Ref No.: BD-ACEPM-SAMCO-LET-040

Project Name: The Big Business District
Contract/Package: Construction Works of the Civil Works for Buildings B1, B2, B3 and B4

Subject: Notice of Slow Progress Rate and Comments on Monthly Progress Report – June 2026

ACE-PM Monthly Review Report – June.2026

- On page 4, under “Project Key Contractual Milestones”:

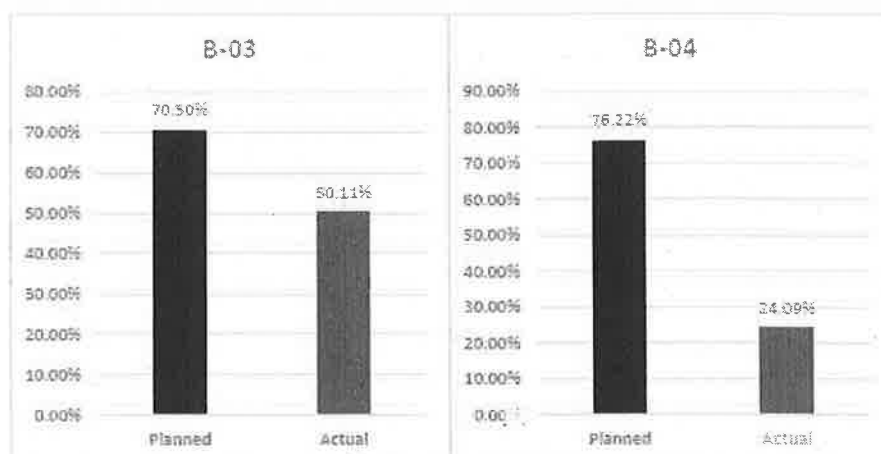
- Based on the submitted XER file (The Project finish date: 5-Sep-2027):

Key Dates		725	0%	11-Sep-25 A	05-Sep-27
Milestone		725	0%	11-Sep-25 A	05-Sep-27
KD-MS-1000	Project Start Date	0	100%	11-Sep-25 A	
KD-MS-1010	Contract Agreement	0	100%	11-Sep-25 A	
KD-MS-1020	IFC Drawing Package	0	100%	11-Sep-25 A	
KD-MS-1040	Ground Works Finish Date	0	0%		08-Oct-26*
KD-MS-1050	Project Finish Date	0	0%		05-Sep-27*
